ORDINARY MEETING	5.3
7 JULY 2015

REQUEST FOR PERMISSIBLE CHANGE TO DEVELOPMENT APPROVAL
(MULTIPLE DWELLINGS) – 19-37 ST CRISPINS AVENUE, PORT DOUGLAS
Jenny Elphinstone: Senior Planning Officer MCUI 901/2015 (DSC TPC1137): (458212)

<u>PROPOSAL:</u>	REQUEST FOR PERMISSIBLE CHANGE TO DEVELOPMENT APPROVAL (MULTIPLE DWELLINGS)
<u>APPLICANT:</u>	BODY CORPORATE FOR POOL COMMUNITY TITLE SCHEME 37139 PO BOX 1 PORT DOUGLAS QLD 4877
<u>LOCATION OF SITE:</u>	19-37 ST CRISPINS AVENUE, PORT DOUGLAS
<u>PROPERTY:</u>	LOTS 0 AND 1-10 ON SP174881 & LOTS 0 AND 11-27 ON SP204456
<u>LOCALITY:</u>	PORT DOUGLAS AND ENVIRONS
<u>PLANNING AREA:</u>	RESIDENTIAL 2 (CURENT SCHEME)
<u>ZONE:</u>	SPECIAL FACILITIES (UP TO 6 MULTIPLE DWELLING UNITS); SPECIAL FACILITIES (UP TO 9 MULTIPLE DWELLING UNITS); SPECIAL FACILITIES (UP TO 11 MULTIPLE DWELLING UNITS) AND SPECIAL FACILITIES (MULTIPLE DWELLING RESIDENTIAL)
<u>PLANNING SCHEME:</u>	DOUGLAS SHIRE PLANNING SCHEME 1996
<u>REFERRAL AGENCIES:</u>	NONE APPLICABLE
<u>NUMBER OF SUBMITTERS:</u>	3 SUBMISSIONS TO THE ORIGINAL DEVELOPMENT APPLICATION
<u>STATUTORY ASSESSMENT DEADLINE:</u>	31 JULY 2015
<u>APPLICATION DATE:</u>	19 JUNE 2015

Project	21 CROSBY AVENUE	Drawn By	ML
Title	UPPER LEVEL PLAN	Checked By	ML
		Date	31st Oct 2003
Project No	AG207	Drawn	A-TP-05
		Rev	02

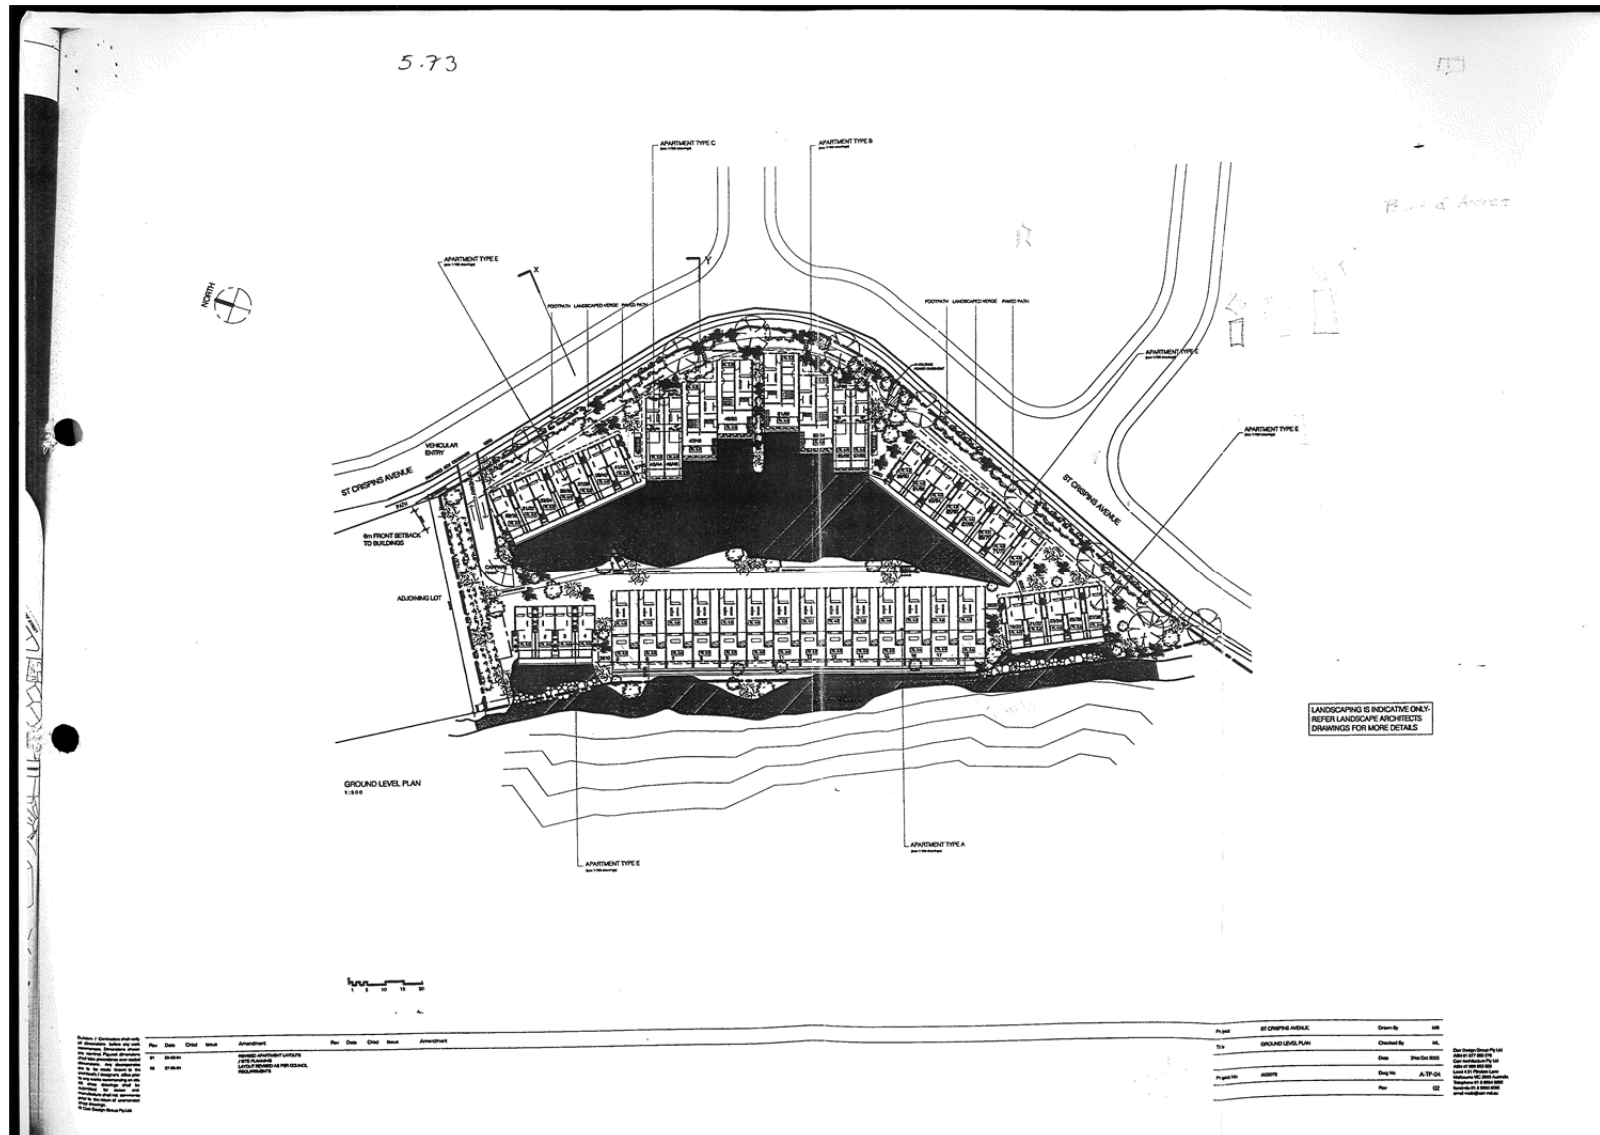
- 4.1 The approved development and the carrying out of any works on the premises associated with the development must be in accordance with Plan of Development No's. A-TP-04 Rev 04, A-TP-05 Rev 04 and A-TP-06 Rev 03 and as varied by the use of a roof design for units 1-10 on SP 174881 and Lot 11-27 on SP204456 on which there is no landscaping developed and in accordance with the Landscape Plan Drawing LP 01 Issue D dated 29 May 2015 prepared by Hortulus Landscape Design and Management, attached to this approval, subject to:
